**Our Ref:** U0011576

**Your Ref:** 2022/0528/P

## **O2 Centre Masterplan Site, Finchley Road – Scheme Amendments**

Open space and landscape  
explanatory note

# 1. From car park to green park

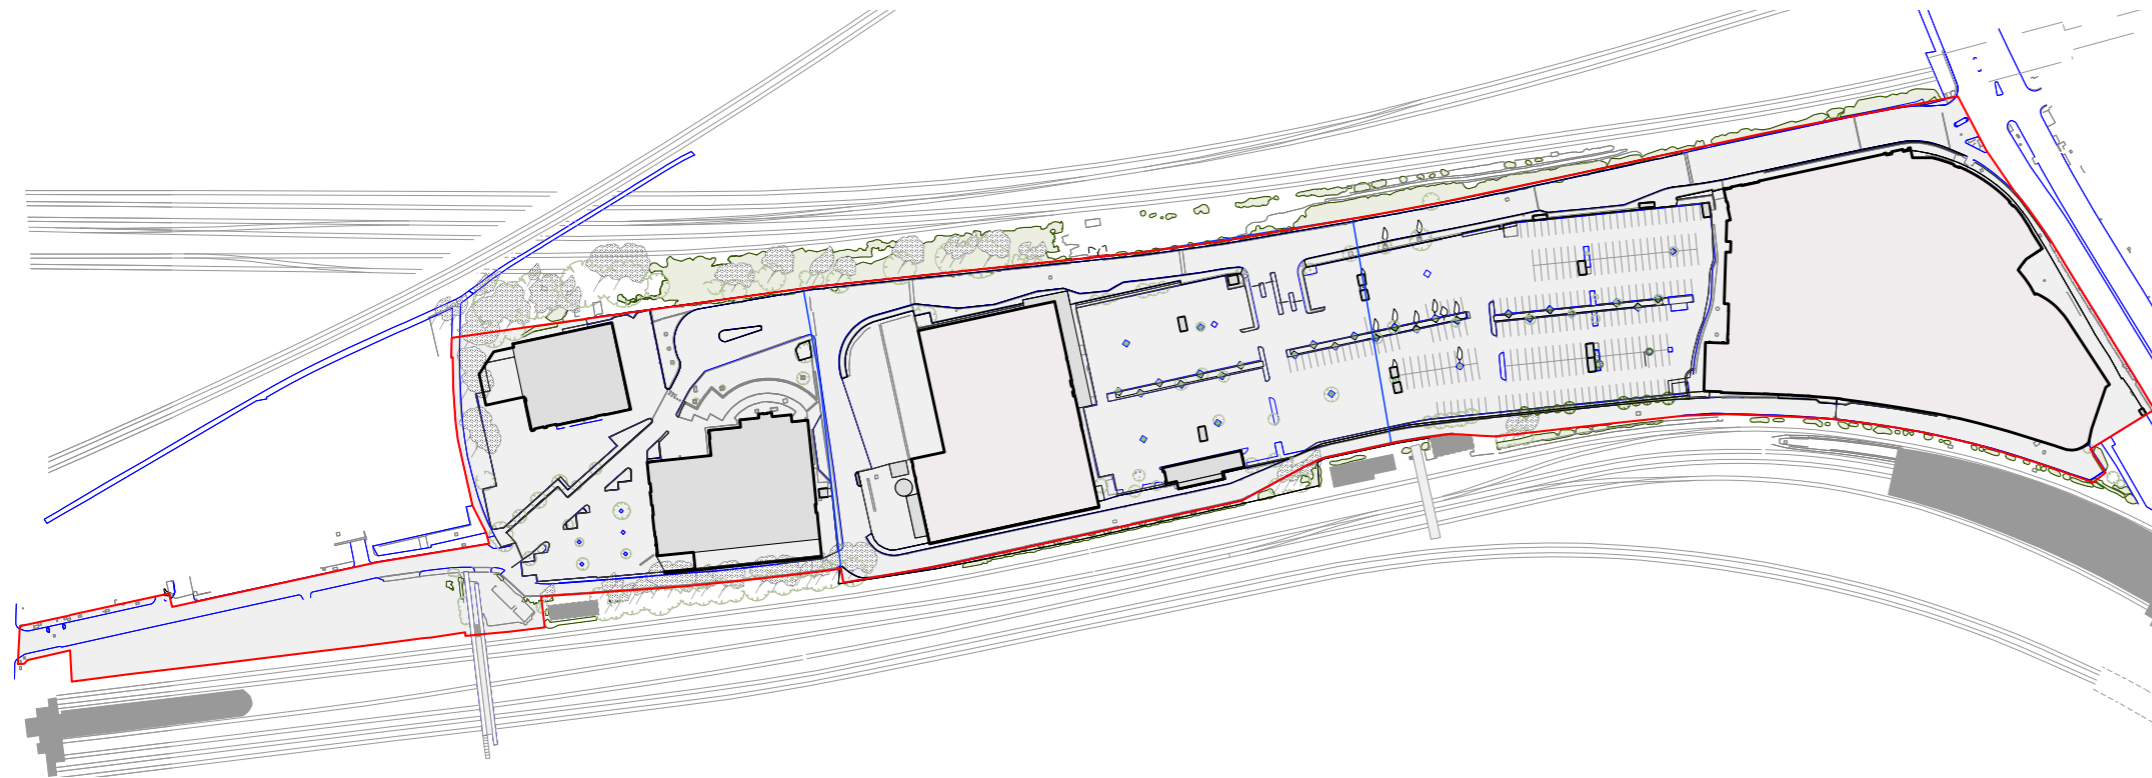
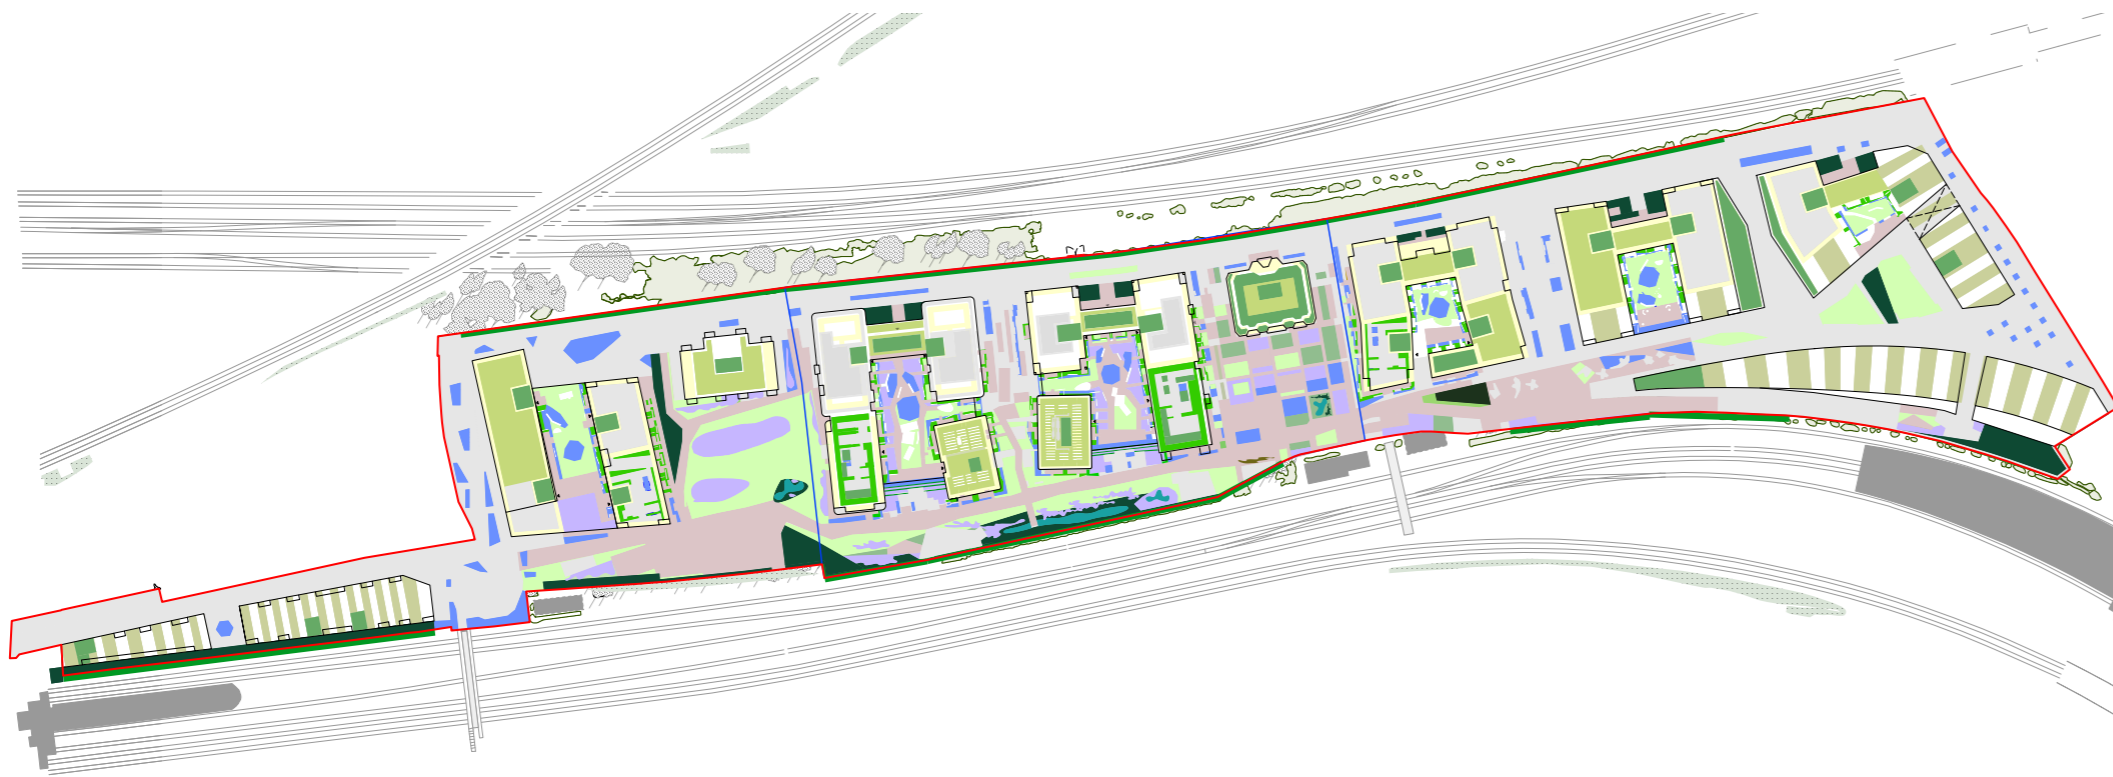
As part of this review, our main actions have been to increase the amount of native climbers on walls along both railway corridors, taking the number from 400 sq. m to over 810 sq. m and to change our extensive roof of sedum to extensive biodiverse solar roofs where possible. With these updates in areas, the detailed phase Urban Greening Factor is now of = **0.37**
